# CULTURAL RESOURCES OFFICE PRESERVATION BOARD

REGULAR MEETING MONDAY FEBRUARY 22<sup>ND</sup>, 2010 1015 LOCUST ST. #1200 4:00 P.M.

SUBJECT: Preliminary Review: Install an awning and retain two brick columns.

SUBJECT: Preliminary Review: Construct a 2-1/2 story single-family house

PROPOSED AWNING

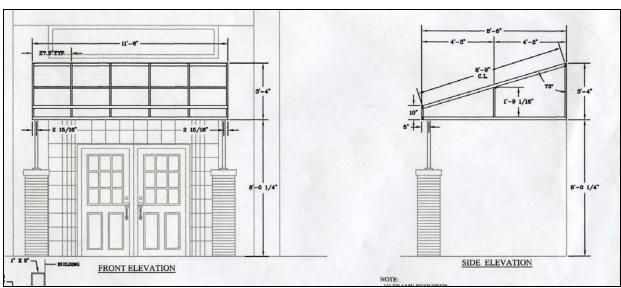
**Does Not Comply:** The awning is not the same shape as the door opening and a proper Model Example was not provided. The awning system will conceal the Moderne detailing and detract from the overall appearance of the entrance. The brick columns are integral to the design of the awning and are not consistent with a traditional awning configuration.

The proposed awning does not fit the opening and would not complement the architectural styling. The columns, which are an integral part of the awnings design, are not centered on the doorway and are a different color brick from the building. The church provided pictures of noncompliant awnings and brick front porches on residential buildings as Model Examples which staff felt did not meet the standards.

PROPOSED FRONT ELEVATION

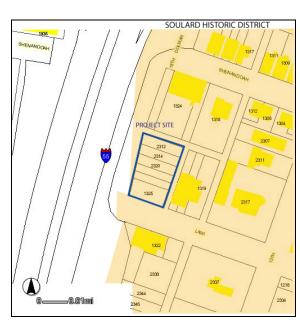
Generally complies. The proposed house is 2 feet wider than the Model Example but

proportions and scale of individual elements are complementary.

<u>Complies</u>. The percentage of openings on the Lami Street elevation complies with this requirement.

<u>Complies.</u> Window proportions are approximately 3 to 6 and replicate that of the window of the Model Example.

EASTERN ELEVATION

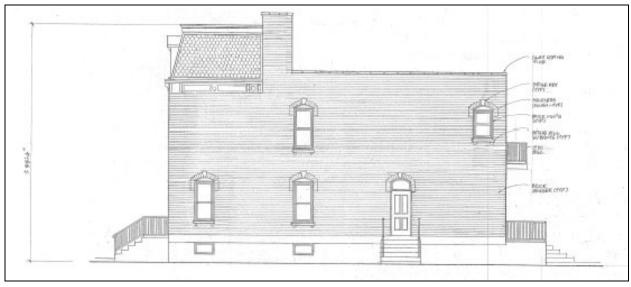
<u>Complies.</u> The front and both secondary (Semi-Public) elevations will be brick veneer.
